SUBJECT: SUP#2003-0115, SUBSTANDARD LOT DEVELOPMENT
301 LAVERNE AVENUE

Docket Item #11
SPECIAL USE PERMIT #2003-0115

ISSUE: Consideration of a request for a special use permit to construct a single family on a substandard lot and a parking reduction.

LOCATION: 301 Laverne Avenue

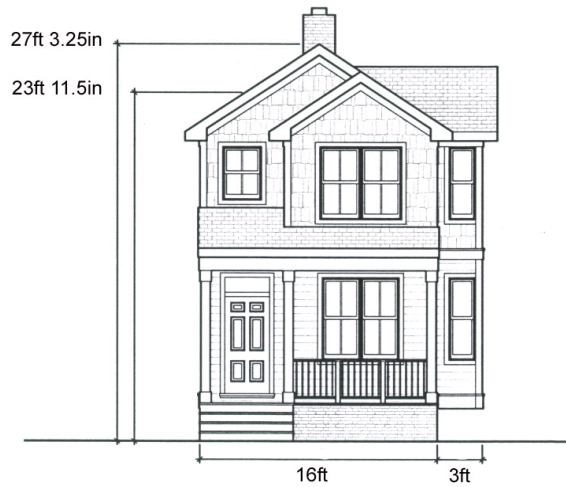
The zoning ordinance recognizes that building a house on a lot that is not as large as the zone may require modifications of the standard zoning rules. Staff can support modifications when they help create development in a way that is more consistent with its immediate surroundings and with the established pattern in the neighborhood than strict compliance with the zoning ordinance would allow. Staff found the substandard lot case being heard at 2001 LaGrande Avenue (SUP#2004-0020) to be an example of the point. In the subject case, however, although some of the modifications are supportable in the abstract, others show how difficult it is to build the applicant's proposed house on this very small lot.

The applicant in this case surveyed the front setbacks of a number of corner properties in the vicinity of the subject property and found that the majority have setbacks less than what the zoning currently requires. The area was built, in the main, prior to the adoption of the current zoning requirements, so the applicant's findings are not surprising. In addition, the surveyed properties are larger than the subject parcel, and in some cases are developed with semi-detached dwellings, discounting their relevance to the requested modifications for the subject property. However, staff agrees that as to the front setback requirement on Laverne, the proposed modification is desirable so as not to have a new house out of character with the others nearby. On the Turner Street frontage however, the small setback (11 feet to the building wall and only eight feet to the large bay windows) is problematic, as it allows a large and long structure (60' long) very close to the street, and completely out of character with the setback of the house behind it.

Staff does not object to a vision clearance modification, in that the streets affected are neighborhood, residential streets, with relatively slow traffic, and because there is a stop sign at Turner Road.

Finally, staff cannot support the rear yard paving modification because the size and location of the house leaves a small side (rear) yard, the parking provided there is not even sufficient to meet zoning requirements and the paving and curbcut require removal of trees.
